Access Compliance Report

Public Rights-of-Way

(Curb Ramps)

Intersection ID: 2489	Main Street: CLARKE_CREEK_PY	Cross Street: HIGHLAND_CREEK_PY	Location:	E
ADA ID: D35DDC2545BD	Ramp Type: PerpDiag	Initial Pass/Fail: Fail	Overall Compliance: No	Severity Score: 10
Codes/Mitigation Info/Possible Solution		Field Measurements/Component Compliance

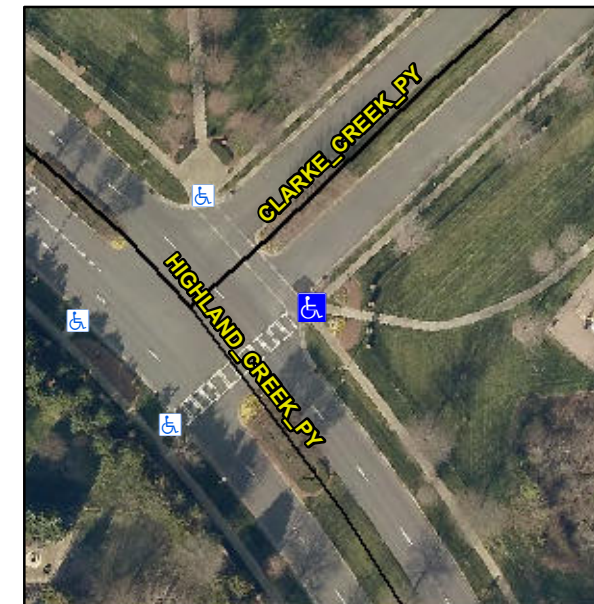
Possible Solutions:

Remove & Replace Curb Ramp With Two New Directional Ramps or Equivalent.

PROW/ADA:

R304.5.1, R304.5.3
